**SUBJECT: Central Valley Meat Company, 2023 Tentative WDR/MRP Comments**

Thank you for providing us with the opportunity to comment on the Tentative Draft of the Waste Discharge Requirements (**WDRs**) and Monitoring and Reporting Program (**MRP**) for the Central Valley Meat Company facility (**CVM**) in Hanford, California. Provost & Pritchard Consulting Group (**Provost & Pritchard**) assisted us with these comments. We have reviewed the WDRs and MRP and are requesting that the following technical and administrative comments be considered:

### **Comment 2. WDR Page 29. Item D. Effluent Limitations**

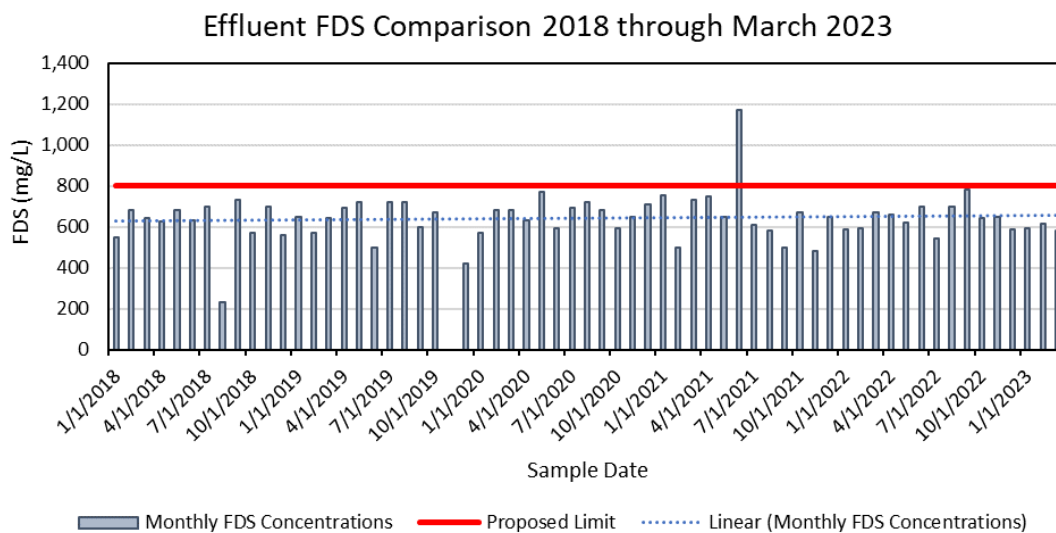
Summary of items in WDR: Item establishes in Table 8 - Salinity Performance-Based Effluent Fixed Dissolved Solids (FDS) Limitation of 800 mg/L to be determined as an annual average.

Response and Comments: It must be noted that the new rendering facility began operations in December 2022. As of this writing in May 2023, the rendering facility is operating at approximately 30% capacity. Therefore, it is currently uncertain what impact rendering at full capacity may have on FDS concentrations of blended processing effluent.

Effluent FDS concentrations from December 2022 through March 2023 ranged from 580 to 613 mg/L, which is generally consistent with effluent FDS concentrations prior to the commencement of rendering. This may not be the case when the rendering facility is fully operational.

Given these factors, it is not appropriate to establish a permanent FDS limit of 800 mg/L without a comprehensive characterization of future effluent quality once the rendering facility is at 100% capacity. **CVM requests that the FDS limit of 800 mg/L be increased to approximately 1,000 mg/L to account for possible increases in effluent FDS concentrations as rendering reaches design capacity.** At a minimum, provisions should be added to the WDR to allow an evaluation of facility FDS concentrations and the ability to modify the FDS limit as conditions change, such as increased rendering and water conservation and reuse efforts.

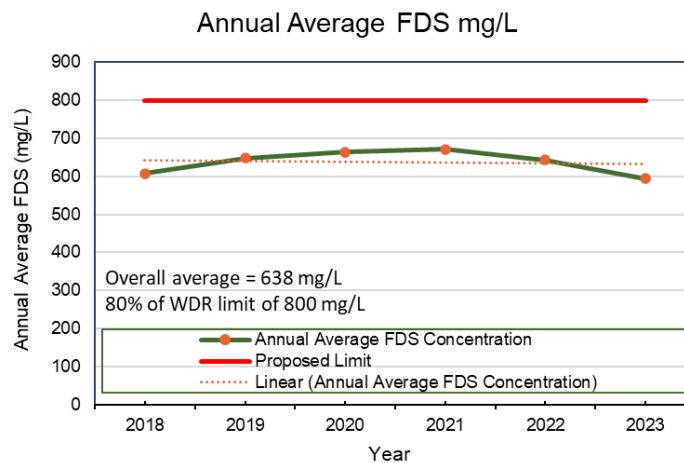
Monthly FDS data from 2018 through March 2023 were also reviewed, compared to the 800 mg/L limit, and summarized in the figure below. Effluent FDS concentrations during this period have consistently been less than 800 mg/L, although one result was substantially greater than 800 mg/L and many results were close to 800 mg/L. There appears to be a slightly increasing trend in FDS concentrations throughout this period.
